NOVA SCOTIA ENERGY BOARD

IN THE MATTER OF: A COMPLAINT by MARTIN AND WENDY TANNER concerning the proximity of electrical, distribution and telecom lines to the main structure on their property.

REDACTED INFORMATION REQUESTS

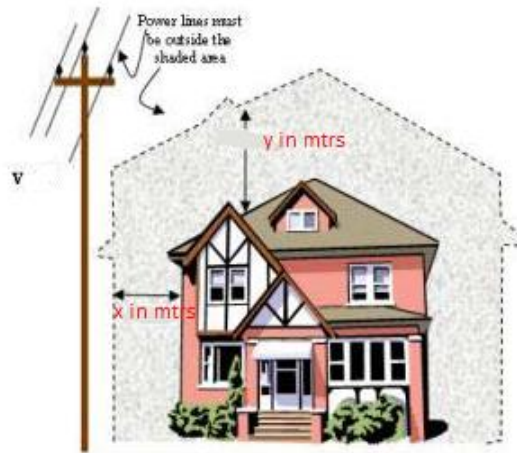
Board staff's understanding is that depending on the voltage of the power line, regulations provide x and y value in meters and the power lines must be outside the shaded region as shown in the image below:

a) Does the Utility concur with the Board staff's understanding as expressed in the above preamble?

i. Please provide the values of x and y, along with the standards used as reference.

ii. Please provide the measurements of x and y for the residence [REDACTED], assuming that the front porch is considered part of the building's protuberances.

iii. Please provide the measurements of x and y for the residence [REDACTED], at the edge the building's front view, including any protuberances. Assume that the front porch is not considered part of the building's protuberances.
